Project: Fillmore High School Modernization

Project Number: WGD 20624 DSA# 03-121233

Addendum 03 – Mechanical Unit Replacement

Date: September 8, 2023

WSXA PDT XX
Dimming Wall Switch, Passive Dual
Technology

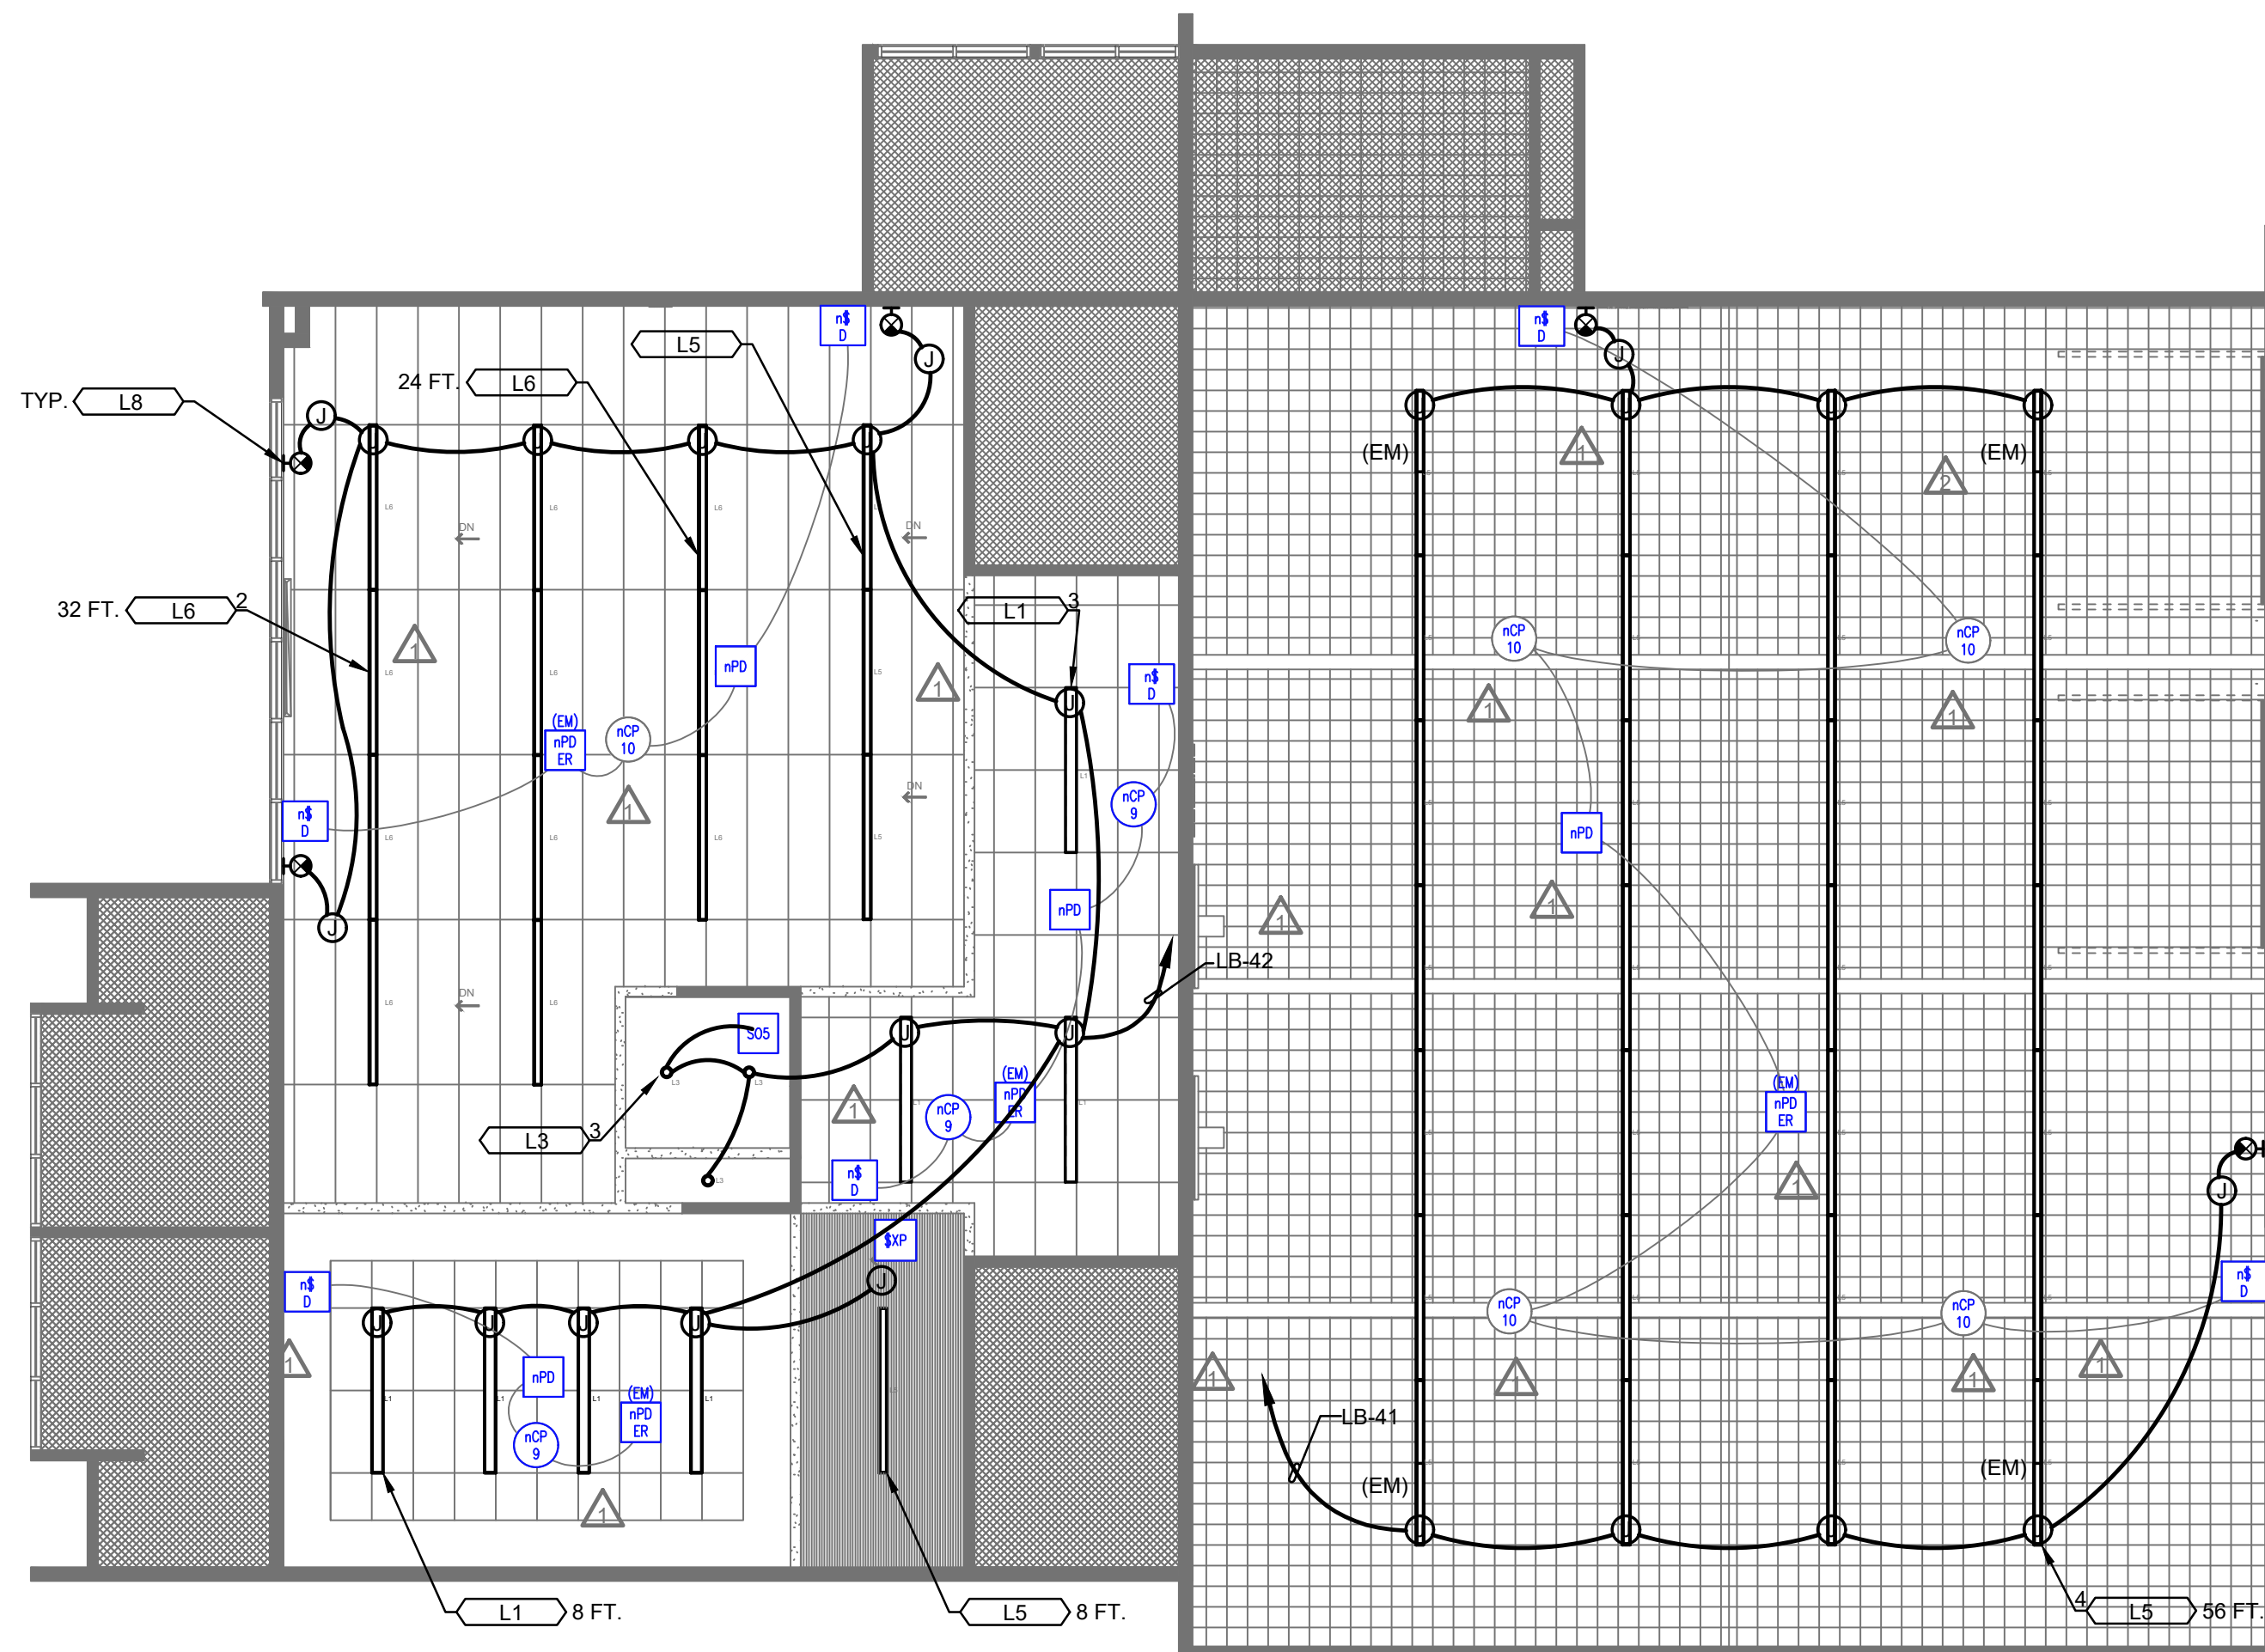
- a. Plan 1-Added circuitry to the building interior connecting new load.
- b. Plan 1-Noted to replace existing panel with panel LB.
- c. Plan 2- Revised power connection for AC-1, 2, &3.
- d. Eliminated panel schedule H8 and added panel schedule LL.
- e. Added Plan Notes 4.
